SOUTH COAST AIR QUALITY MANAGEMENT DISTRICT

Draft Staff Report

Proposed Amended Rule 1110.2 – Emissions from Gaseous- and Liquid-Fueled Engines

Proposed Amended Rule 1100 – Implementation Schedule for NOx Facilities

Figure 1: NO_x Emissions for ICE 1 on February 17, 2018

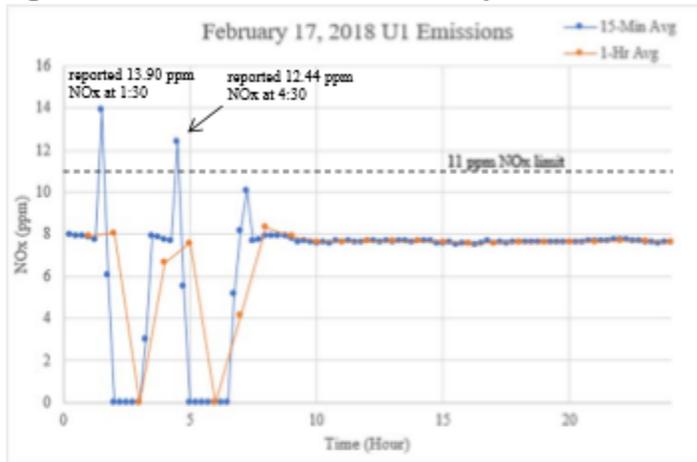
As shown in Figure 1, the operator typically responds to high emission alarms by shutting down the engine in an attempt to avoid exceeding the 15-minute average limit. Engine shut-downs create transients in otherwise stable operations. Following shut-down, the probable cause is diagnosed as quickly as possible and the engine restarted. Start-ups typically cause emission transients until the system reaches stable operation, during which time the emissions are exempt from meeting

permit limits. The cycle of shutting down the engine and restarting results in more emissions in comparison to allowing the engine to remain operating.

South Coast AQMD appreciates your comments and agrees that a longer averaging time can result in less emissions. Regarding your request to increase the averaging time from 15 minutes to 60 minutes, PAR 1110.2 has been revised to allow a 1-hour averaging period for engines equipped with CEMS.

Figure 2: NO_x Emissions for ICE 1 on March 19, 2018

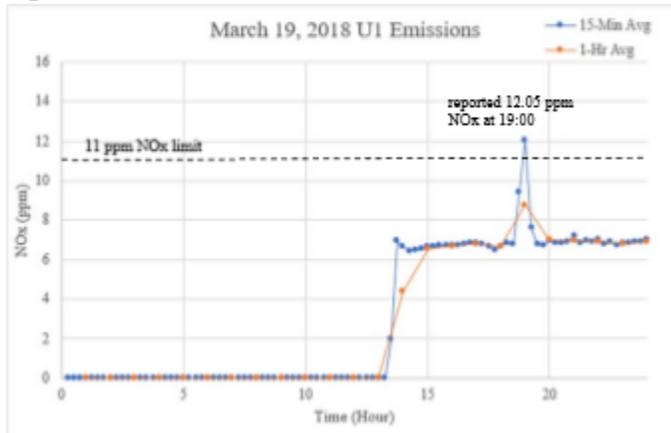
In Figure 2 we see continuous operation past the exceedance, showing that this exceedance corresponds only to one 15-minute data point and is not sustained over an extended time period. Hourly NO_x emission averages would allow the system to continue operating past such short-term spikes such that it can re-stabilize without measures such as powering down, which may cause greater fluctuations in NO_x output.

Figure 1 – SCR Characteristic Curve

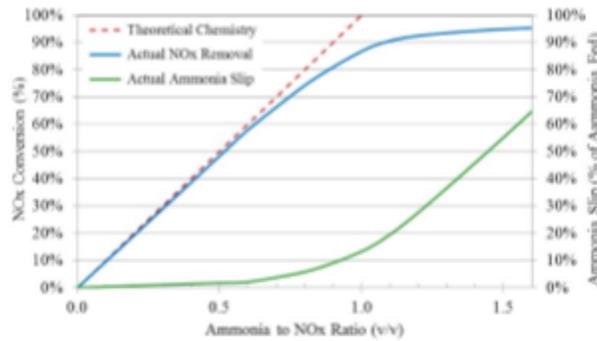
The concern is that the SCR technology being applied to these compressors has practical limitations that must be considered when setting the limits to provide reliable performance. All SCR systems operate on the principle of providing a target percent NOx removal for a percent ammonia slip. As an illustration, Figure 1 below shows the SCR characteristic curve for an SCR system with an inlet ammonia-to-NOx distribution of 10% RMS; a well designed, state-of-the-art system and the most widely accepted design basis for gas fired SCR applications. In this design, to achieve 90% NOx reduction 20% excess (above stoichiometric) ammonia is needed. This 20% excess ammonia exits the reactor as ammonia slip. If the system has an inlet NOx of 25 ppmvdc NOx and 90% removal is achieved, the stack NOx is 2.5 ppmvdc and the ammonia slip is 5 ppmvdc. If, however, the inlet NOx is 100 ppmvdc then the stack NOx would be 10 ppmvdc and the ammonia slip would be 20 ppmvdc.

The SoCal Gas compressors have an engine exit NOx of 100 to 150 ppmvdc. At 150 ppmvdc NOx and 11 ppm Stack NOx, 92.7% NOx removal is required. However, for 92.7% NOx removal 25% excess ammonia is needed and ammonia slip would be 37.5 ppmvdc. Some engines may have the capability to adjust combustion ratios and reduce NOx, but only at the expense of increasing VOCs.

Figure 2 – Engine Exit NOx Moreno Compressor vs IC Engine Generator

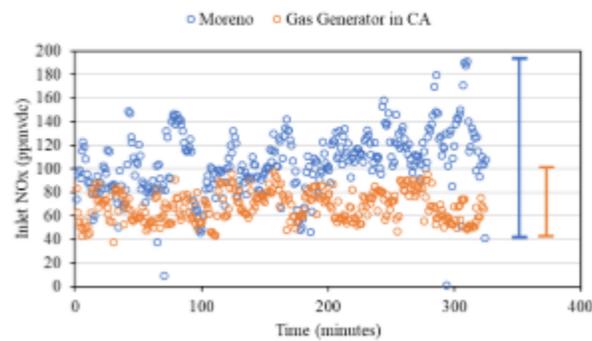
Further, unique to the operation of the compressors is wide and sudden variation in engine exit NOx. Figure 2 illustrates this point by comparing actual operating data between a typical lean-burn IC engine gas generator and the Moreno engines. The variation in engine exit NOx at Moreno is more than twice that of a gas fired generator.

Conventional ammonia flow control systems have a lag in response time as an artifact of the feed forward and/or feedback control signals from the CEMS. When wide variations occur, the control system is consistently lagging and the result is over or under injection of ammonia and increased variation on stack NOx and ammonia slip. This would typically be allowed for by longer averaging periods of 12 to 24 hours. In lieu of that, increased NOx and ammonia slip limits are necessary to compensate for these variations. It is also worth noting that the gas generator used in this illustration is located in California and is permitted with a 3-hr rolling NOx averaging period.
